PRODUCT CHANGE NOTICE

1. TITLE IRFM360 SOA Change		2. DOCUMENT NUMBER FV5-C-15-0002
		3. DATE December 19, 2014

14. PRODUCT CHANGE
This GIDEP PCN is to announce a change in the SOA performance for the following International Rectifier Part No.

400V Single N-Channel Hi-Rel MOSFET in a TO-254AA package

New IRFM360 SOA Curve:

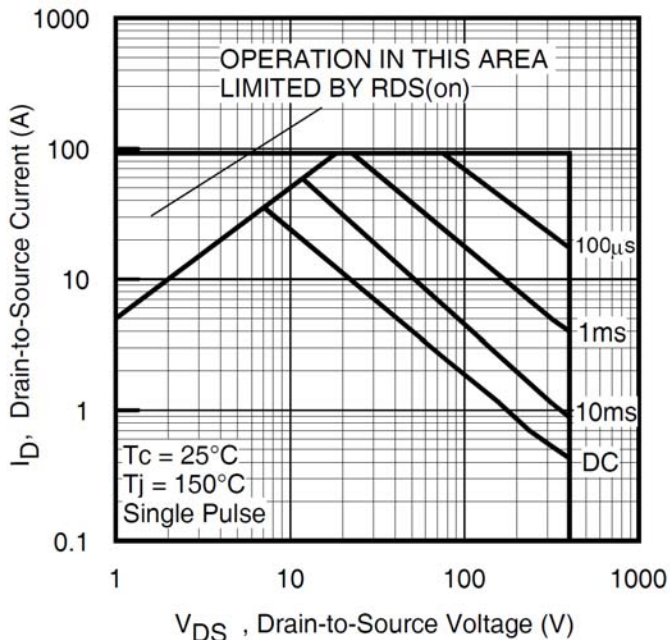
SOA specification at 80% of V_{DS} , and 10mS from: $I_{AS} = 3A$ to: $I_{AS} = 2A$
